Applic. No. 10/536,581  
Amdt. dated June 14, 2007  
Reply to Office action of March 14, 2007

Drawing Amendments

Remarks/Arguments:

FIG. 1A

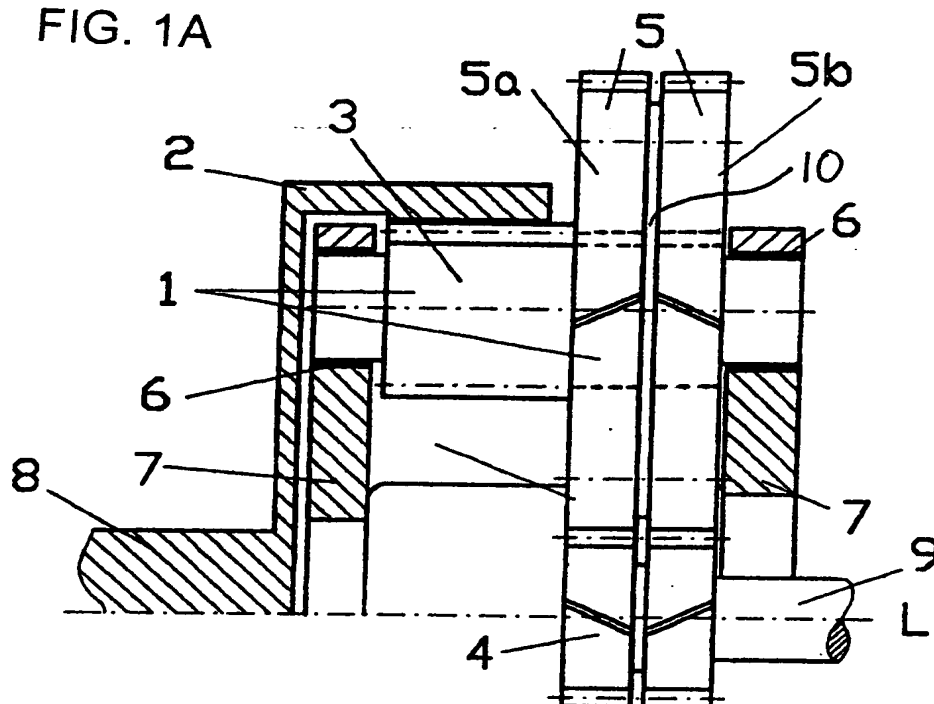
The attached sheet of drawings includes changes to Fig. 1A. This sheet which includes Figs. 1A and 1B, replaces the original sheet including Figs. 1A and 1B. In Fig. 1A, previously omitted reference symbol 10 and hidden lines designating the shortened tip were added.

More specifically, the Examiner has stated that devices for axial and/or rotational displacement in claim 12, cup springs of claim 20, toothing profile of the straight-toothed planetary gearwheel with a tip thereof shortened, as a shaft profile for the axial guidance of one or of both half wheels by way of a corresponding inner profile on the shaft of claim 21, adjusting plates of claim 22, and devices to orient said second half wheel with respect to said first half wheel of claim 24, must be shown or cancelled from the claims.

Fig. 1a has been changed to show the feature of claim 21 that the toothing profile of the straight-toothed planetary gearwheel with a tip thereof shortened, as a shaft profile for the axial guidance of one or of both half wheels by way of a corresponding inner profile on the shaft. Accordingly, the objection to the drawing by the Examiner pertaining to claim 21 has been overcome.

Fig. 1a has been amended to include the reference numeral "10", which designates the adjusting plate. Accordingly, the objection to the drawing by the Examiner pertaining to claim 22 has been overcome. The specification has also been amended to reflect the change.

With respect to claim 24, applicants note that Fig. 1 has been amended to designate the plate and the shortened toothing of the straight-toothed gearwheel. Both of these features are

Please approve the drawing changes that are marked in red on the accompanying "Annotated Sheet Showing Changes" of Figs. 1A and 1B. A formal "Replacement Sheet" of amended Fig. 1A is also enclosed.

Regarding claim 12, the drawings have been amended to include the adjusting plate "10" and the shortened tips of the

straight-toothed gearwheel. Therefore, the drawings show the devices for axial and or rotational displacement.
